WINCHESTER SOUTH PROJECT  
WATER AND FINAL LANDFORM ADDENDUM

JUNE 2023  
Project No. WHC-18-62  
Document No. 01185344-006.docx

**Figure 4-13A – Alluvium/Colluvium Drawdown Area (Layer 1) Sensitivity Derivatives – Recharge**

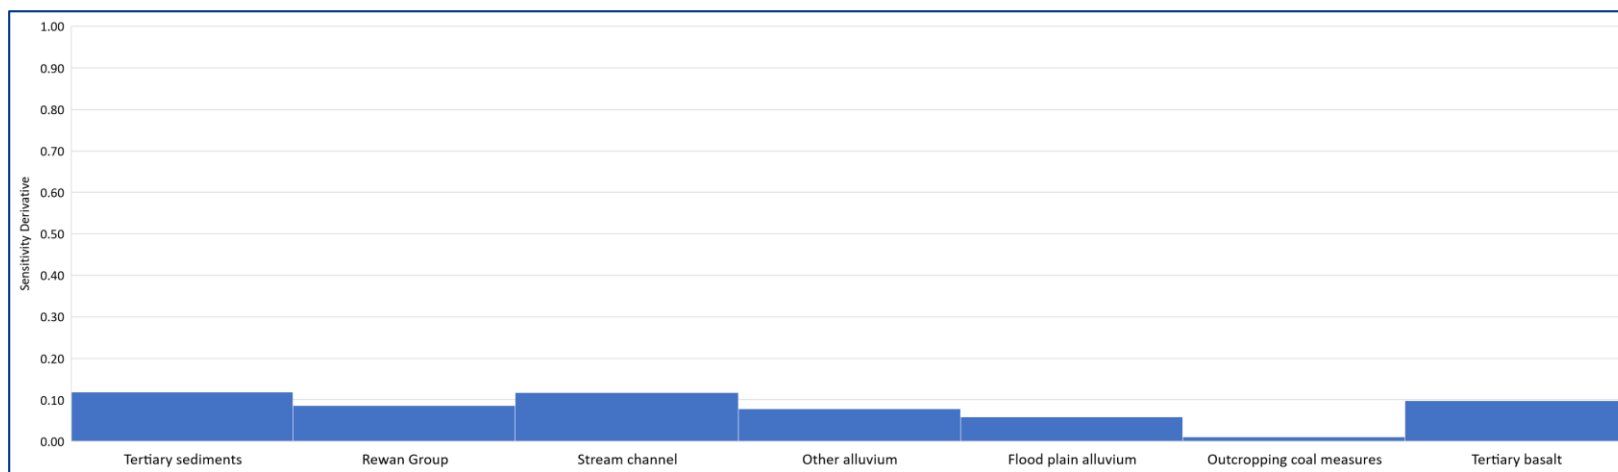
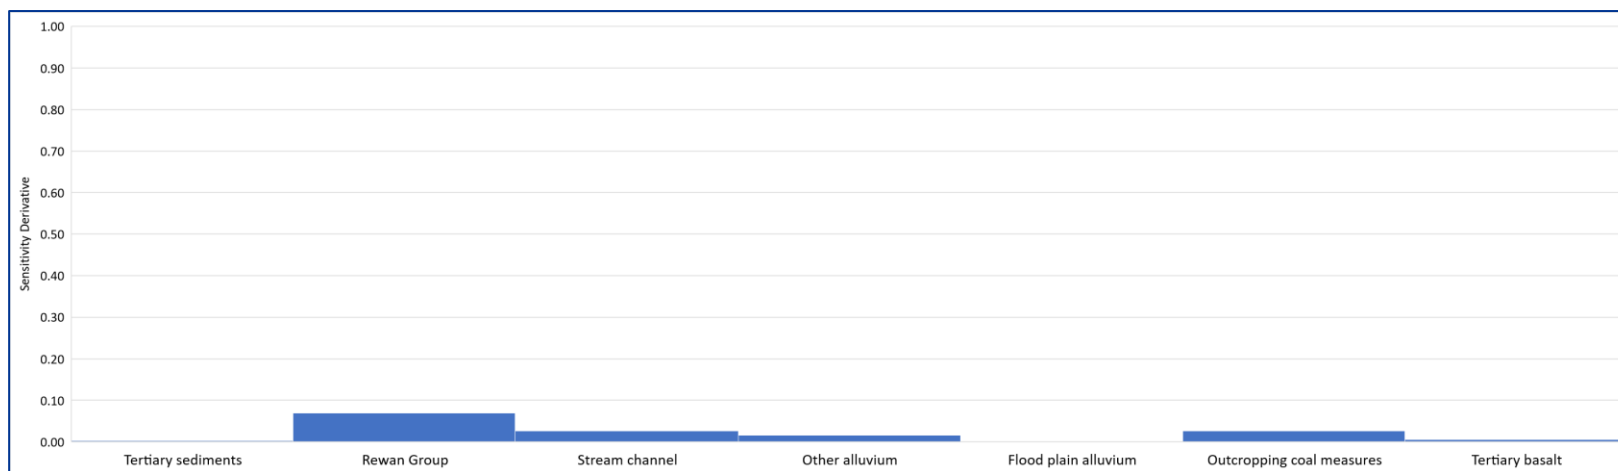
*Expand the sensitivity and uncertainty analysis to a greater range of hydrogeologic parameters, or clearly justified as to why this is not necessary.*

The sensitivity and uncertainty analysis undertaken by SLR for the Groundwater Assessment included analysis of recharge parameters to evaluate potential changes to the future climate. Different recharge zones were applied to the model for areas of different mapped surficial geologies. Figures 4-13A and 4-13B (from Appendix B of the Groundwater Assessment) show that the results of the predictive sensitivity analysis for these recharge zones provide sensitivity derivatives of less than 0.2 for all recharge zones, in terms of the effect of recharge on groundwater drawdown predictions. This indicates little sensitivity of the model drawdown predictions to applied recharge rates. Therefore, recharge (from rainfall) is considered to be less impactful to model predictions and therefore, climate change would have limited effect on the outcomes of the numerical groundwater modelling.

Figure 4-21A – Predicted Groundwater Particle Movement over 2,000-year Simulation for the Final Landform

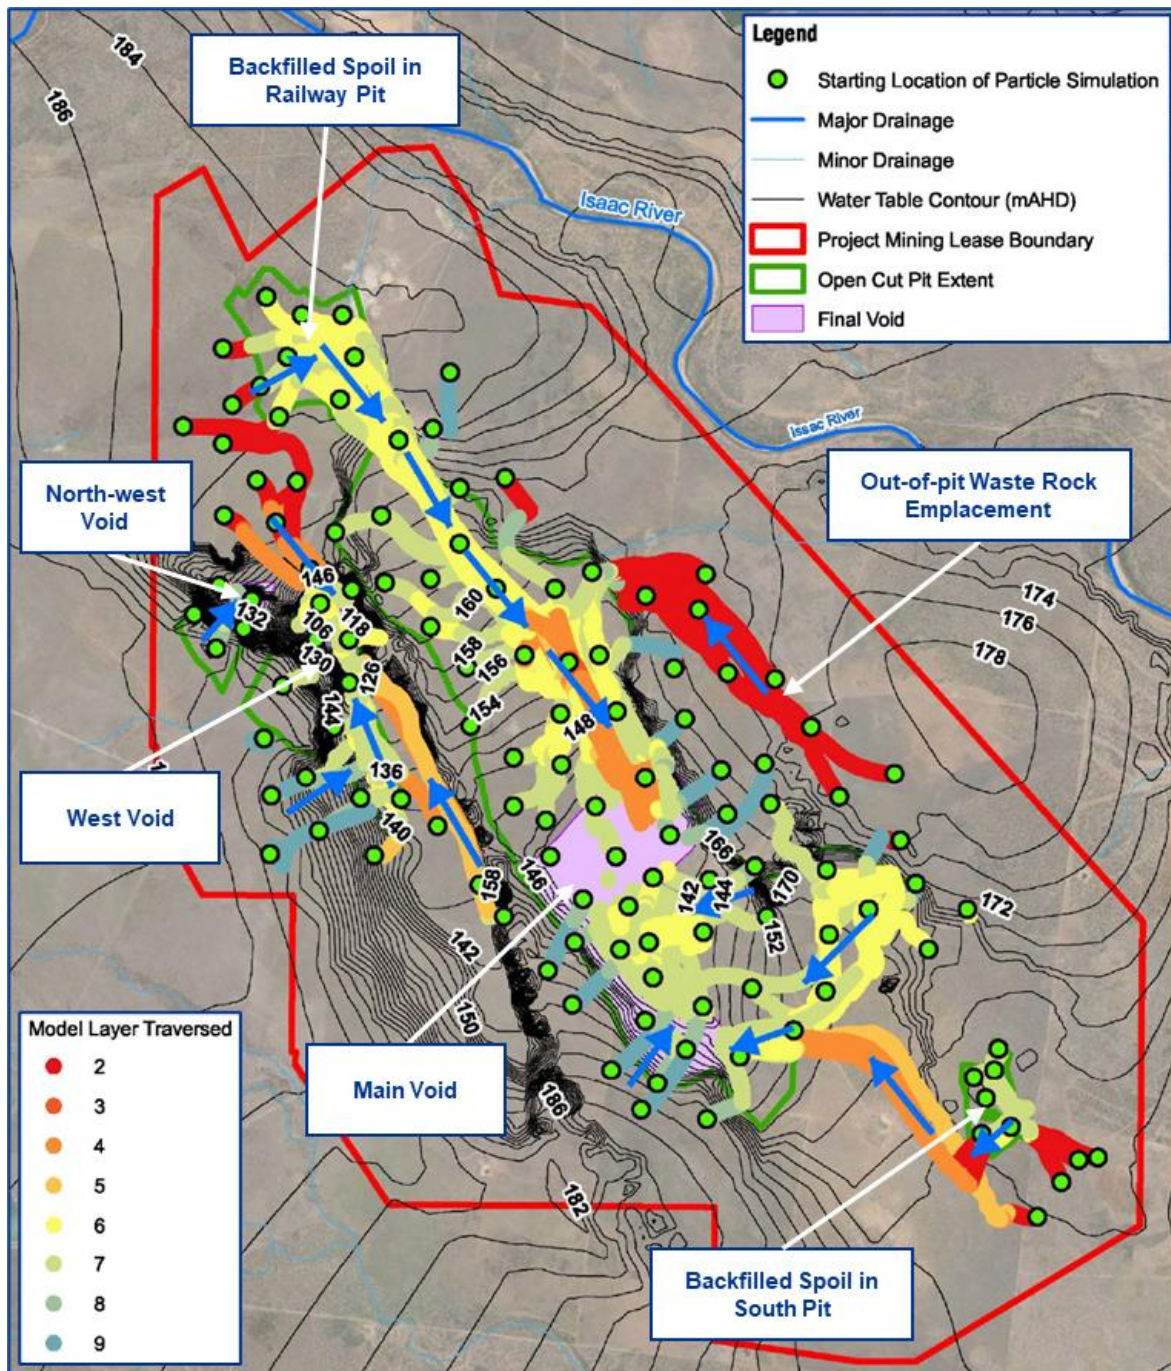
*The modelled recovery period considers a 2,000 year period post mining, however the main void might not necessarily behave as a sink as shown in the Predicted Residual Void inflows plot (SLR 2022, Figure 4-3, App. B, p. 57) as it appears to behave as a source for the first 150 years. See also DES issue 584.23 (original issue 480.25) that identifies the north-west void as a source rather than a sink.*

No water that flows from the residual void water bodies into the backfilled spoil migrates off-site or to the downstream receiving groundwater regime (e.g. Isaac River alluvium, regolith, etc.), thus the final landform is acting as a groundwater sink. This conclusion was validated via groundwater fate modelling (e.g. particle movement simulations) to simulate the flow of water throughout the final landform (Figure 4-21A). The groundwater particle movement simulation predicted that water within the backfill spoil and West Void would not flow off-site, therefore demonstrating that as a whole the residual voids would remain groundwater sinks in perpetuity (generally driven by hydraulic gradient towards the residual voids, particularly the West Void).

Figure 5-1A

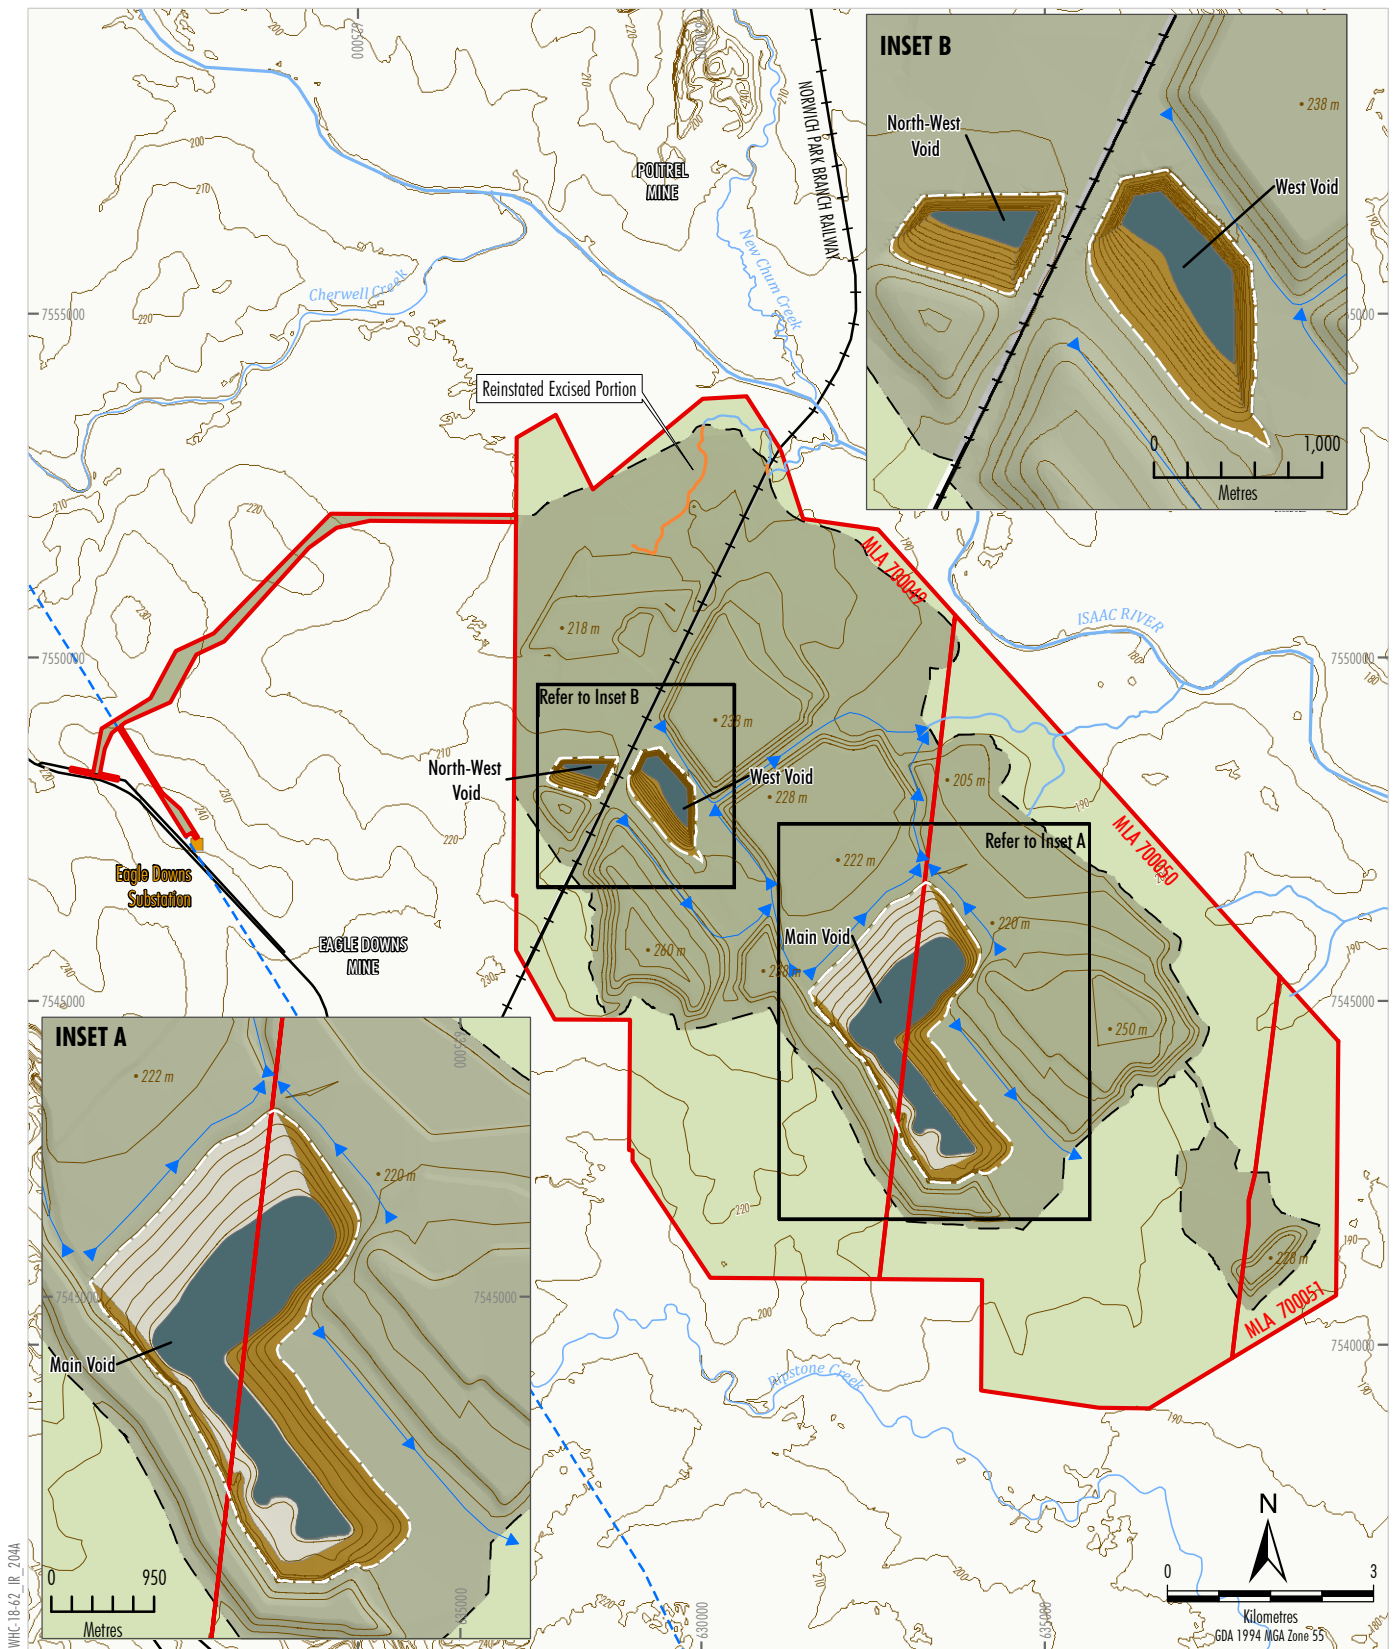
*Long-term closure strategies for residual voids require remediation methods that are self-sustaining and **require no or limited management inputs and maintenance (e.g., pump and treat remediation, nutrient addition, in-lake liming).** Treatment technologies can be classified as either active or passive treatment. Active treatment requires continuous operation and maintenance and is often used in operating mines when there are personnel on site and revenue is dedicated to water treatment. Passive treatment is intended to be self-sustaining after an initial set-up phase and is ideal for treating mine water after closure although some level of management is inevitable. **Active treatment technologies are generally only implemented post-closure where there is a risk of contamination to social or environmental receptors or as a requirement in the beneficial reuse of void water.***

In consideration to feedback received throughout the assessment process, Whitehaven WS reviewed the Project mine plan and sequence with the aim of reducing the number of residual voids in the final landform, reducing the impacts of the Project on threatened species habitat and investigating uses for the residual void water bodies. The final landform for the Project (Figure 5-1A), would achieve these improvements by:

**Figure 5-2A**

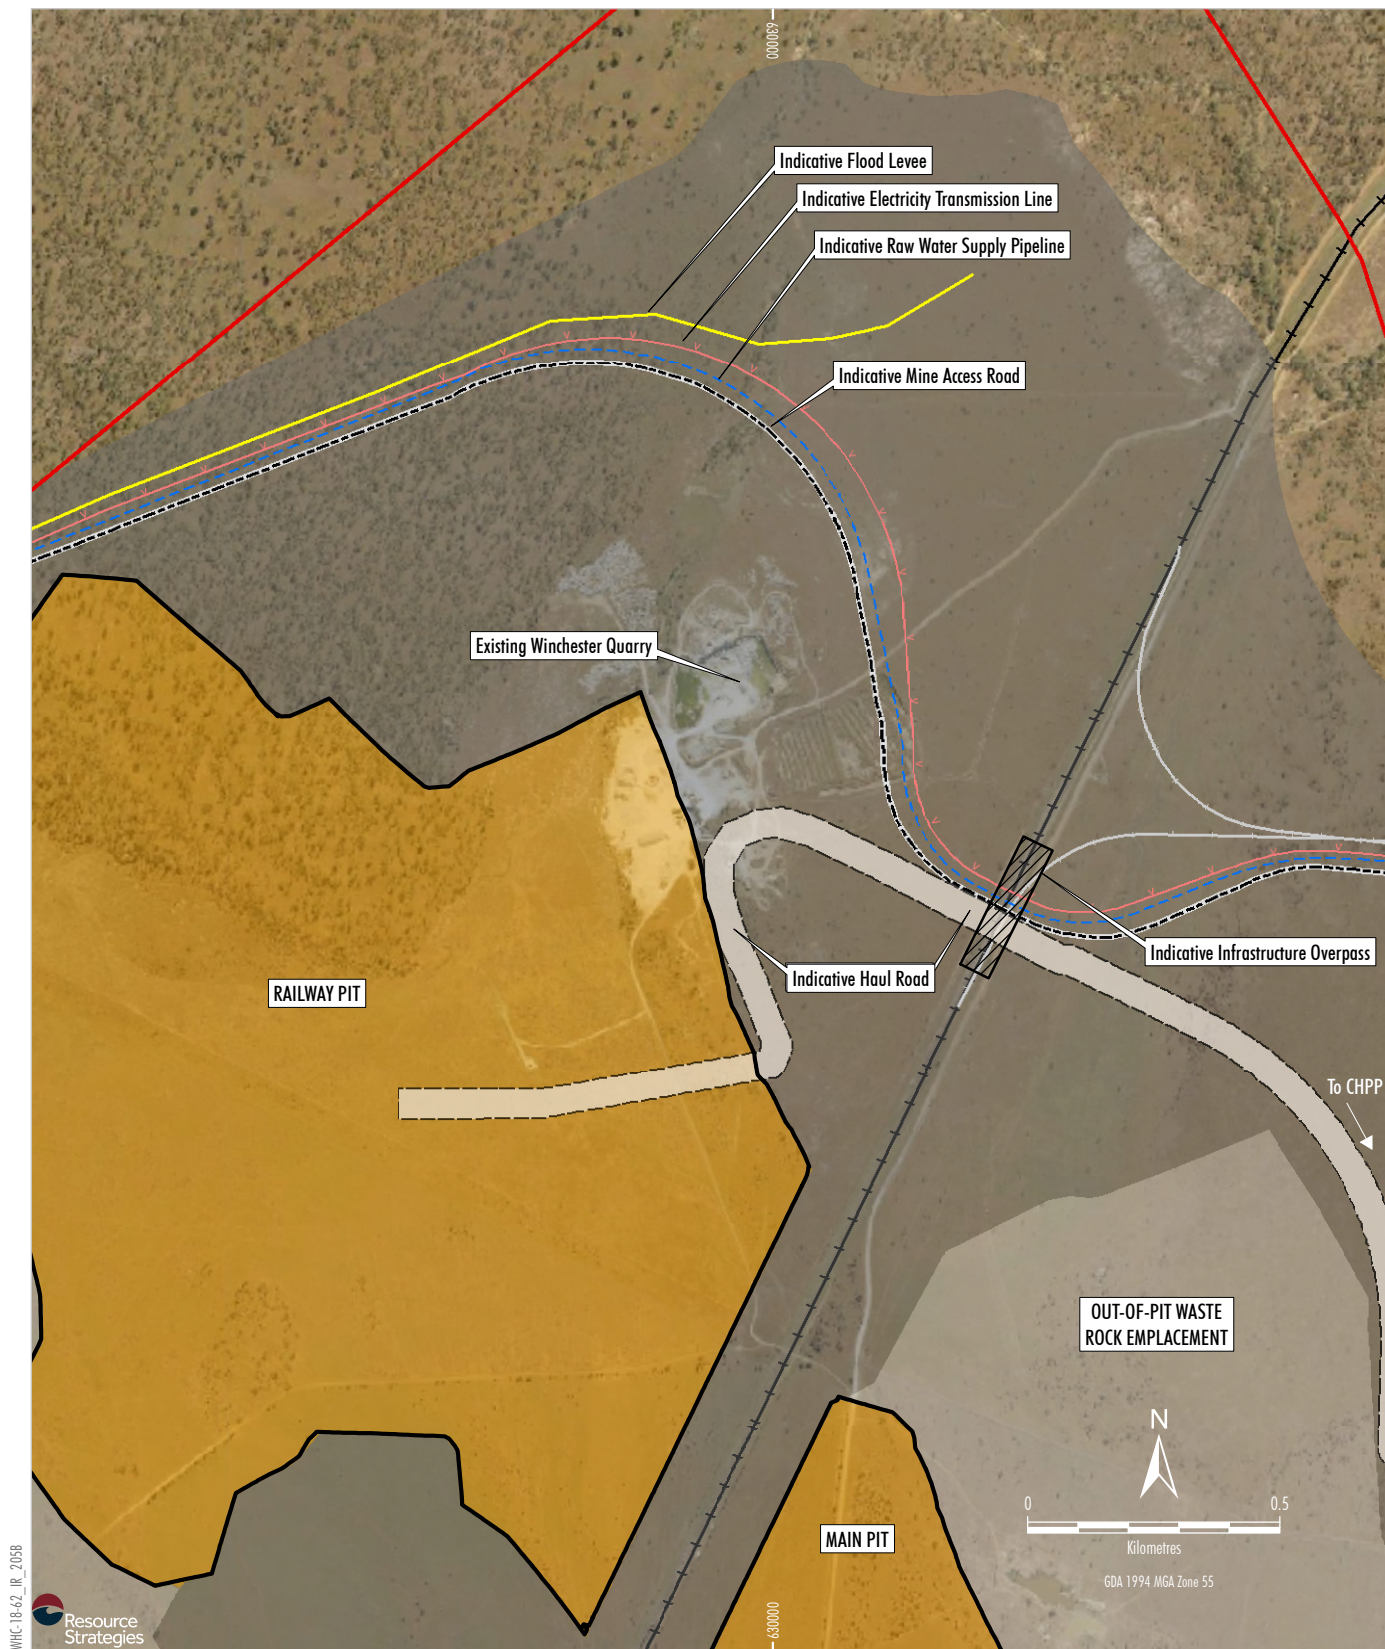
*It is not clear from information provided to date how operation and rehabilitation of the quarry will be clearly delineated from mine operation and rehabilitation. The proposed disturbance footprint for the Winchester South project appears to overlies parts of the existing quarry footprint and areas such as topsoil stockpiles. See Figure 1 at the end of this document.*

The interactions for each stage of the Winchester South Project (the Project) and the Winchester Quarry (the Quarry) are set out below. These arrangements will be documented in an agreement between Whitehaven WS, Quarrico (the operator of the Quarry) and the landowner (the holder of Environmental Authority [EA] 0001796 for the Quarry, which is also a development approval under the Queensland *Planning Act 2016*), as necessary. Figure 5-2A reproduces the figure included in the Final Landform and Residual Voids RFI and DES information request.

Commencement of mining operations for the Project in vicinity of the Quarry (Project Years 2 to 29): Prior to commencement of mining activities in Railway Pit for the Project, Whitehaven WS will notify Quarrico and require it to cease quarrying operations and vacate the area of the Quarry. The area of the Quarry will become part of Whitehaven WS' operational areas and activities in that area will be carried out in accordance with the mining EA, Progressive Rehabilitation and Closure Plan (PRCP) and Whitehaven WS' SSE responsibility.

If the landowner does not require retention of the Quarry at the end of the Project life, the EA for the Quarry will be surrendered on the basis that the rehabilitation conditions of the PRCP for the Project will address all rehabilitation requirements of the EA for the Quarry. Alternatively, if the landowner intends to continue operation of the Quarry at the end of the Project life, the EA for the Quarry will remain on foot, but no activities will be carried out under the EA.

Rehabilitation (Project Year 30 onwards): Whitehaven will progressively rehabilitate any disturbance it has carried out in vicinity of the Quarry area in accordance with its EA and approved PRCP for the Project. If the landowner does not require retention of the Quarry at the end of the Project life, it will be backfilled and the Quarry area rehabilitated to a low intensity grazing post-mining land use (PMLU) consistent with the surrounding land. Alternatively, if the landowner intends to continue operation of the Quarry at the end of the Project life, Whitehaven WS will reflect the area as a quarrying PMLU, having regard to the EA for the Quarry status as a development approval. In that case, rehabilitation of any part of the Quarry area not disturbed by Whitehaven WS would be carried out by the landowner/Quarry operator in accordance with the EA for the Quarry.
